RE: **13424 Cedarbrook Ave NE**
Grading and Drainage Plan
Engineer's Stamp Date: 9/24/18
Drainage File: F23D013

Based on the submittal received on 9/24/18, the grading and drainage plan cannot be approved until the following are corrected and a complete resubmittal is made:

ENGINEER'S SEAL 9/24/18 DAVID SOULE P.E. #14522	13424 CEDARBROOK AVE.	DRAWN BY DEM
	GRADING AND DRAINAGE PLAN	DATE 9-23-2018
	 Rio Grande Engineering 1800 CENTRAL AVENUE SUITE 301 ALBUQUERQUE, NM 87108 (505) 872-0000	SHEET # 1 OF 1 JOB # XXXXX

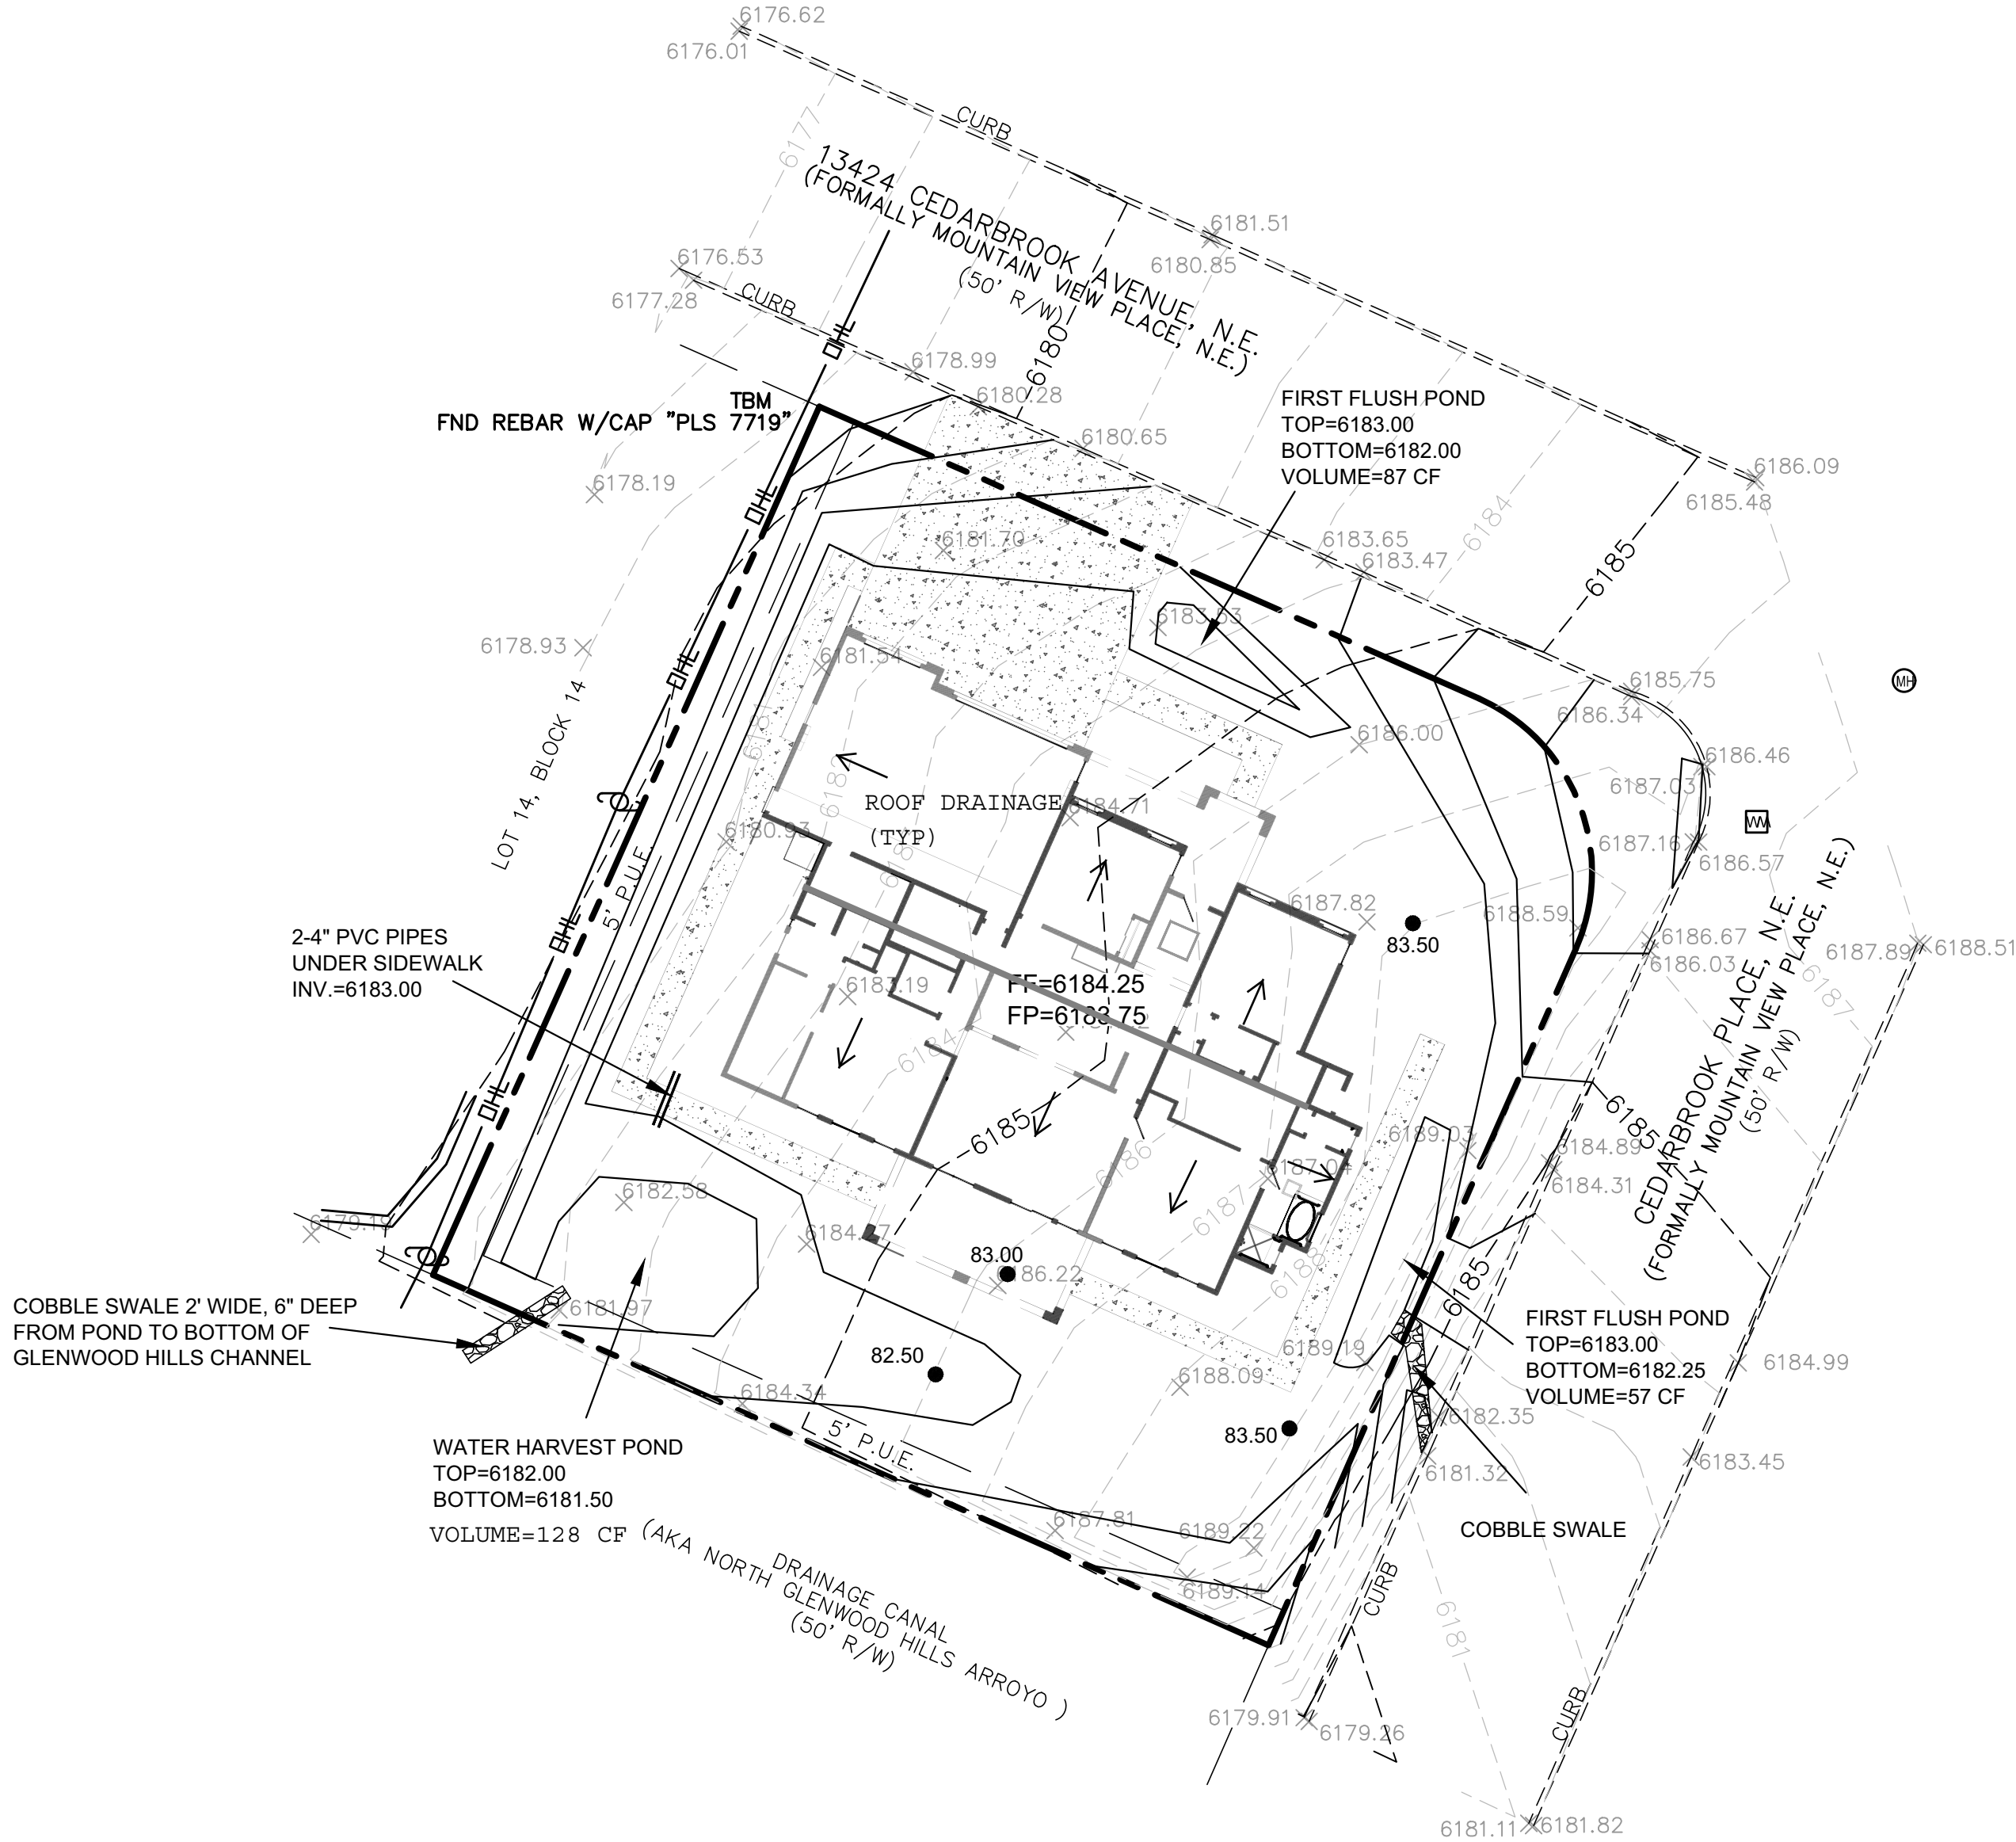
1. Show the adjacent grades in N Glenwood Hills Arroyo; ensure that your grading ties-in at the ROW line. Do not lower the grade adjacent to the arroyo.
2. Label the proposed contours.
3. First flush is not required on single residences; the ponds may be removed if desired.
4. Because N Glenwood Hills Arroyo is an unnumbered A-zone; make a reasonable assumption as to the 100-yr water surface elevation at the upstream edge of this lot and ensure the pad is elevated above it (+1ft freeboard recommended).
5. Do not regrade the ROW along Cedarbrook Place; it's keeping the water in the arroyo.
